Corrigendum to RFP for DC Renovation and Shifting

Corrigendum to RFP for DC Renovation and Shifting			
Page No. Clause No/Heading	Existing RFP Clause		Amended Clause
15&16, 13, Implementation Schedule	Billing cycle will commence after successful completion of acceptance testing for all locations.		Billing cycle for Annual Maintenance Support Charges will commence after satisfactory handover.
15&16, 13, Implementation Schedule	The Bidder shall be responsible for delivery and installation of the ordered item(s) at the site and for making them fully operational at no extra charge within 6-10 weeks of the date of purchase order.		The Bidder shall be responsible for on door delivery and successful installation of the ordered item(s) to the satisfaction of the Bank and for making them fully operational at no extra charge within a period of 12 weeks from the date of work order.
	Bidder to implement the solution within TEN WEEKS FROM THE DATE OF WORK ORDER.		Bidder to implement the project within TWELVE WEEKS FROM THE DATE OF WORK ORDER.

Addendum to RFP for DC Renovation and Shifting	
86, Appendix D , o , Network Distribution System :	<p>The bidder will provide following:</p> <p>Network

Appendix-B Proposed DC area with dimension

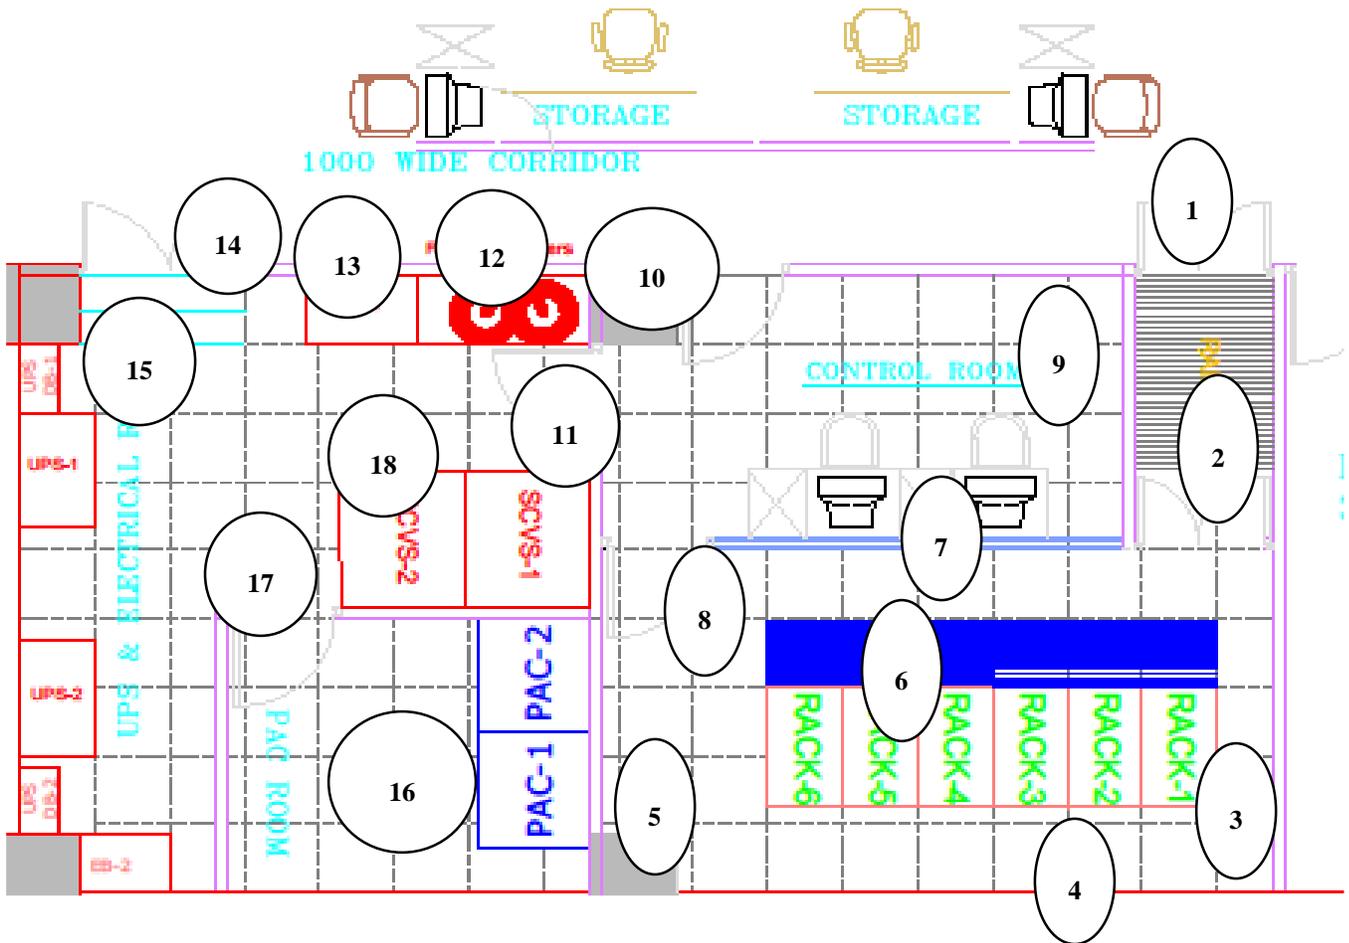
SI No	Description	Area in mm/Sqmtr
1.	Total area	10150x5500 (LxB) = 54.41 Sqmtr (Approx.)
2.	DC area	19.80 Sqmtr
3.	Electrical room	17.30 Sqmtr
4.	PAC room	7.7 Sqmtr

5.	Control Room	9.61 Sqmtr
6.	Emergency door size	2.7 Sqmtr
7.	Entry door size	2.0 Sqmtr
8.	True floor to true ceiling	3530 mm
9.	True floor to false floor	450 mm
10.	True ceiling to false ceiling	600 mm
11.	False floor to false ceiling	2830 mm
